Well Name: SAKER 6-7 FEDERAL COM	Well Location: T24S / R35E / SEC 6 / LOT 2 / 32.251867 / -103.40253	County or Parish/State: LEA / NM
Well Number: 14H	Type of Well: OIL WELL	Allottee or Tribe Name:
Lease Number: NMNM014164	Unit or CA Name:	Unit or CA Number:
US Well Number: 3002549462	Operator: OXY USA INCORPORATED

Type of Submission: Notice of Intent

Type of Action: APD Change

Procedure Description: Oxy USA Inc., respectfully requests approval to amend the subject well AAPD to change the BHL and amend the casing to our 3-string slim w/ T95 Production Casing design. See attached APD sundry change overview worksheet along with the updated well plat and drilling documents. Please note: The well pad did not change. It is renamed Falcon_T24SR35E_6_Pad 2. "NO CHANGE TO SHL AND NO ADDITIONAL SURFACE DISTURBANCE RELATED TO THIS SUNDRY"

Wellhead diagram during skidding operations

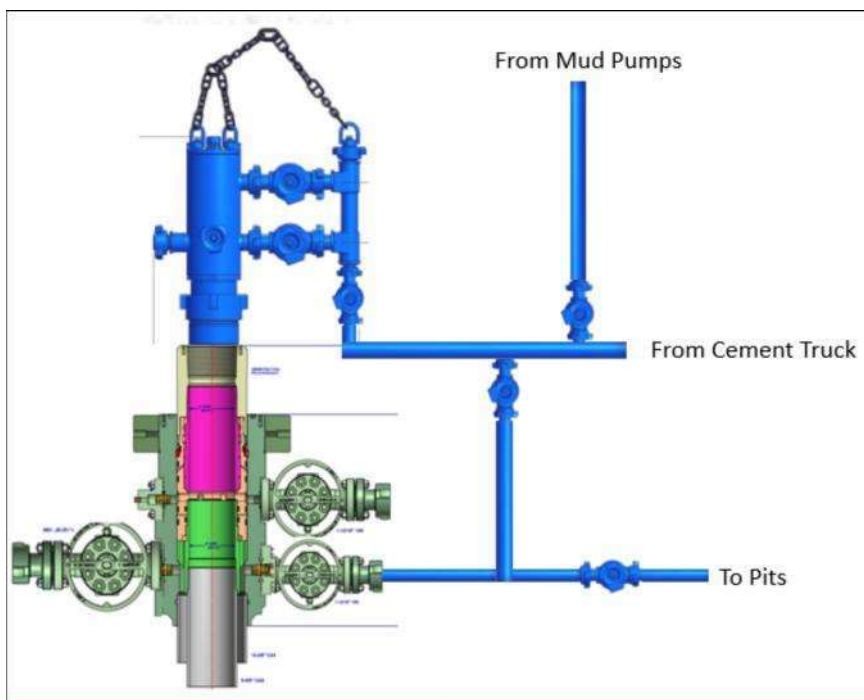
1. Run casing as per normal operations. While running casing, conduct negative pressure test and confirm integrity of the float equipment (float collar and shoe)
2. Land casing with mandrel
3. Fill pipe with kill weight fluid, do not circulate through floats and confirm well is static
4. Set annular packoff shown below and pressure test to confirm integrity of the seal.
Pressure ratings of wellhead components and valves is 5,000 psi

5. After confirmation of both annular barriers and internal barriers, nipple down BOP and install cap flange.
 - a. If any barrier fails to test, the BOP stack will not be nipped down until after the cement job is completed with cement 500ft above the highest formation capable of flow with kill weight mud above or after it has achieved 50 psi compressive strength if cannot be verified.

Form C-102
Revised August 1, 2011
Submit one copy to appropriate
District Office

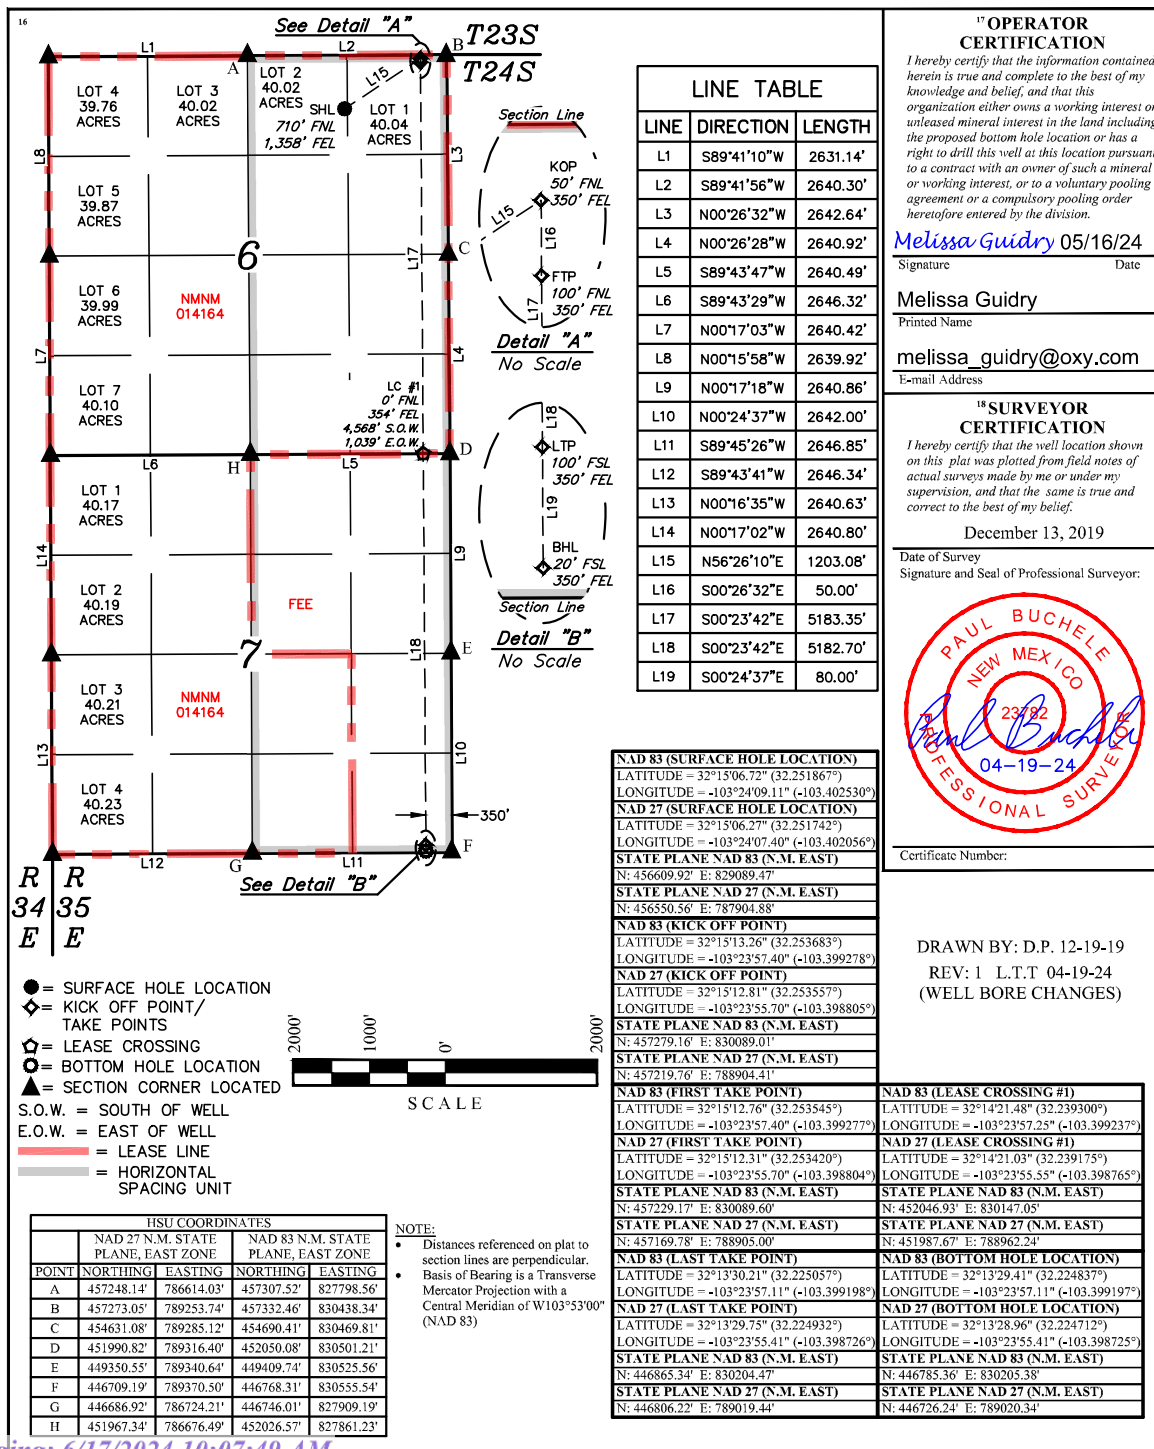
¹¹ Bottom Hole Location If Different From Surface

UL or lot no. P	Section 7	Township 24S	Range 35E	Lot Idn	Feet from the 20	North/South line SOUTH	Feet from the 350	East/West line EAST	County LEA
¹² Dedicated Acres 640.06		¹³ Joint or Infill	¹⁴ Consolidation Code		¹⁵ Order No.
